CERTIFICATE OF APPROPRIATENESS

Property: 3711 Audubon Place, Tracts 21 & 22A, Block 16, Montrose Neighborhood Subdivision. The property includes a historic 1,374 square foot, one-story stucco single-family residence and detached garage situated on a 6,625 square foot (53' x 125') interior lot.

Proposal: Alteration: Windows

Front Elevation – Left of Front Door

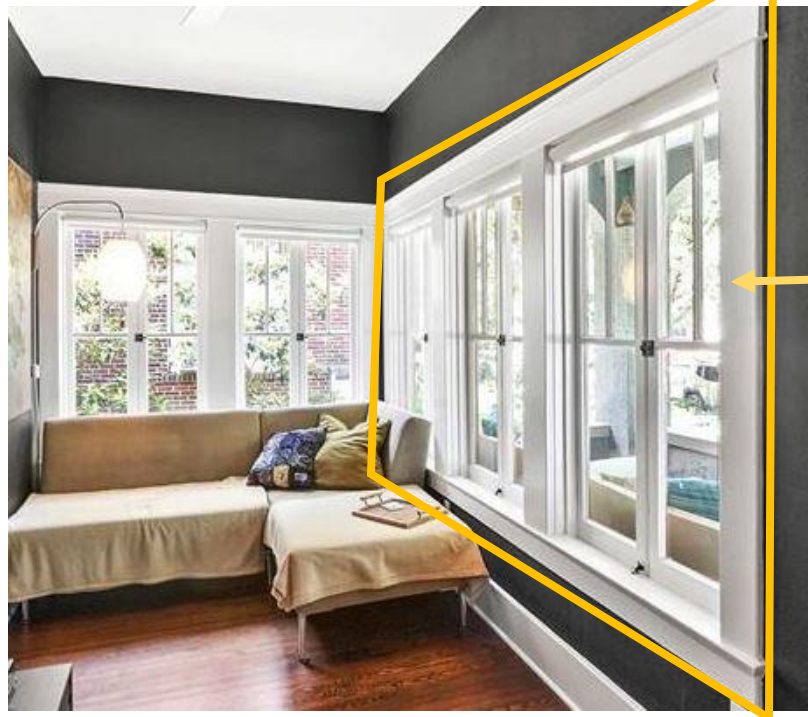
- Replaced windows on front and right elevations without a COA or permit
- Red tagged 5 times since 5-10-2024
- Replaced 5 windows with Jeld-Wen wood windows, 1-over-1 lite pattern, DH, inset & recessed
- Grogan spec sheet states that was ordered in 09-2023 with three vertical grids on upper sashes but never installed due to cost per applicant
 - Applicant states that pieces of wood would be surface mounted to replicate the three vertical grid patterns
 - Applicant chose not to install windows as indicated on the Grogan spec sheet with the vertical grids on upper sashes

| <input type="checkbox"/> | <input checked="" type="checkbox"/> | <input type="checkbox"/> | (1) The proposed activity must retain and preserve the historical character of the property; The completed activity did not retain and preserve the historical character by installing windows that did not match the existing grid patterns on upper sashes. |

Recommendation: Denial and Issuance of COR: Re-install an original window on the front left elevation. If a window on the rear elevation fits, that may be used, or a new all wood window matching the window lite pattern that was removed. Replace all the windows that were removed on the front right elevation and right side with wood windows that match the lite pattern and style of the windows removed.
